**Subject: Response to NRC Comments on the Draft Airborne Radiological Survey for
Fort McClellan**

**Response to Comments by the U.S. Nuclear Regulatory Commission
on the Airborne Radiological Survey – Main Post and Pelham Range
Fort McClellan, Calhoun County, Alabama**

Response to NRC INSPECTION REPORT NO. 01-028161-05/03-01

RADIOLOGICAL EVALUATION OF THE PELHAM RANGE P4 ANOMALY AT FORT McCLELLAN, ALABAMA

Figure 3-1

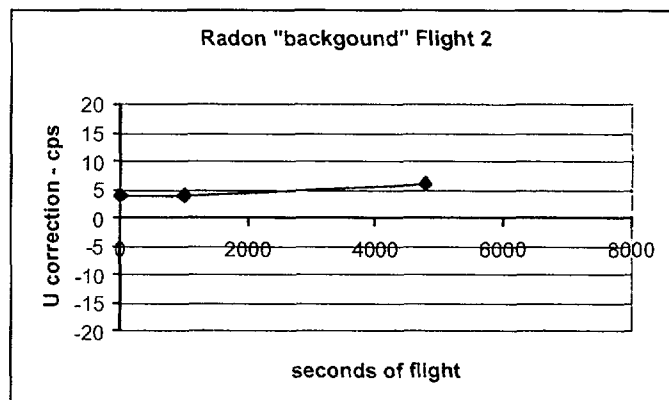
Comment 4: Discussion in the report indicates that radon background measurements could not be performed because there were no upward-looking detectors utilized during the survey. Radon banding was observed in the uranium window and to a lesser extent in other windows and was adjusted to base levels to match local backgrounds on a line by line basis. According to the report, this correction may cause errors in defining absolute background and concentration values, but does not affect identification of point source anomalies. Please provide additional information regarding this stripping technique, particularly a reference, to allow for validation of this conclusion.

In an attempt to identify only those flights that require background adjustment, the count rates from the repeat test line were reviewed. Repeat measurements over the Ft. McLellan survey test line allow for the demonstration of differences in survey conditions which are likely due to radon variation for specific flights. Under the assumption that the test line is flown at the same altitude and starts and stops in the same place each day, variation in the average daily count rates in the uranium window in particular, will be primarily due to the presence of radon background. This procedure was used to identify flights that might contain elevated radon backgrounds during the Ft McLellan surveying. Average Uranium counts for the test line are plotted against average Thorium, Potassium and Total Count channels – an example of which is shown in Figure 3-1 for Thorium versus Uranium. From this analysis, flights 2,3,17,20,24,27,29 and 30 in particular, are seen to have elevated average count rates in the Uranium window.

Figure 3. Fort McClellan Pelham Range P4 Anomaly – Shale Outcropping

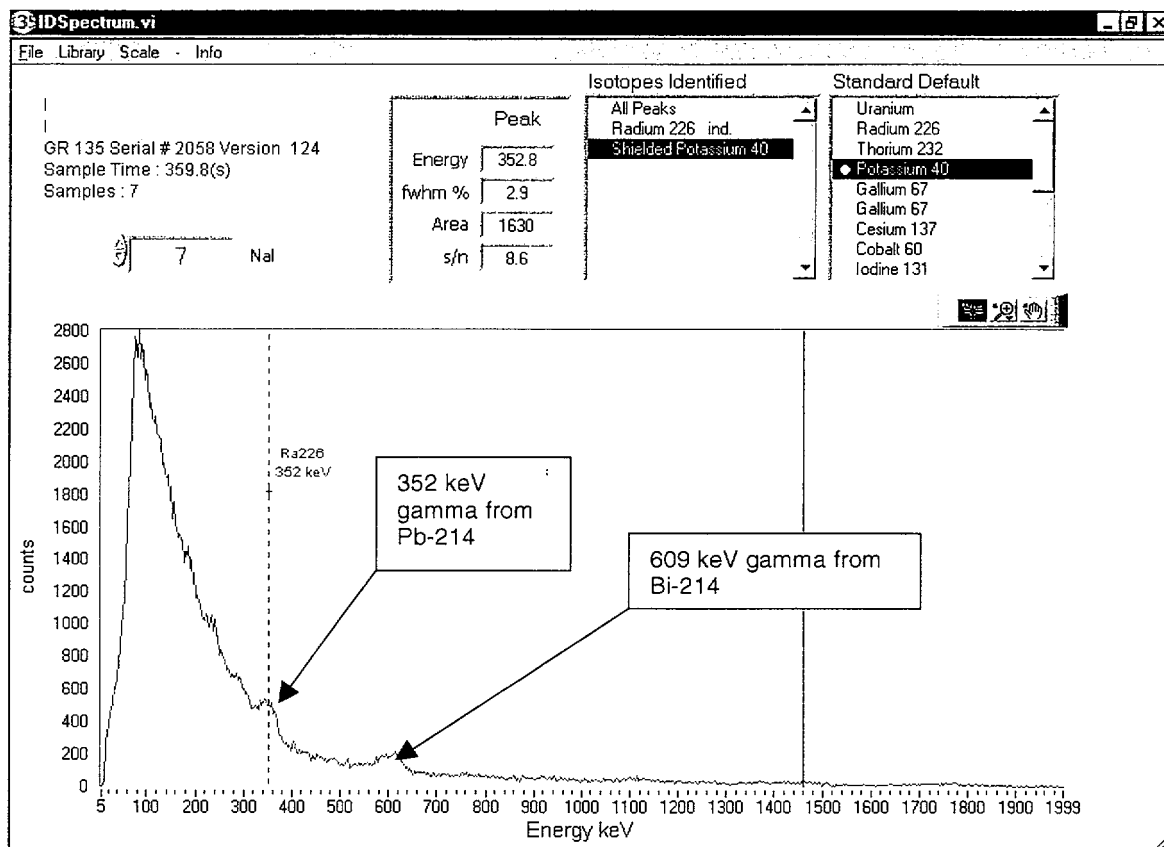
Comment 7: Anomaly P4 had elevated Co-60 in addition to elevated exposure rate, unlike P3 and P5 through P10, which only exhibited elevated exposure rates. The P4 ground investigation exposure rate measurement was significantly greater than other shale outcropping anomalies. In addition, the exposure rate at the surface was nearly two times the one-meter measurement, compared to the other anomalies where the exposure rates did not significantly change with distance. During the M2 anomaly ground survey, the hand-held NaI spectrometer drifted and incorrectly identified Cs-137 in the spectrum. Because of the exposure rate results and potential for misidentification, or non-identification, for the P4 anomaly, please provide additional information supporting your conclusion that the elevated readings in this area were due to the shale outcropping.

Surface exposure rates ranged from 8 to 42 microroentgens per hour ($\mu\text{R/hr}$) with the higher exposure rates being associated with extensive visible shale outcroppings at anomaly P4 (see Figure 3). One-meter exposure rates ranged from 5 to 21 $\mu\text{R/hr}$, again, with the higher exposure rates recorded at the P4 anomaly.
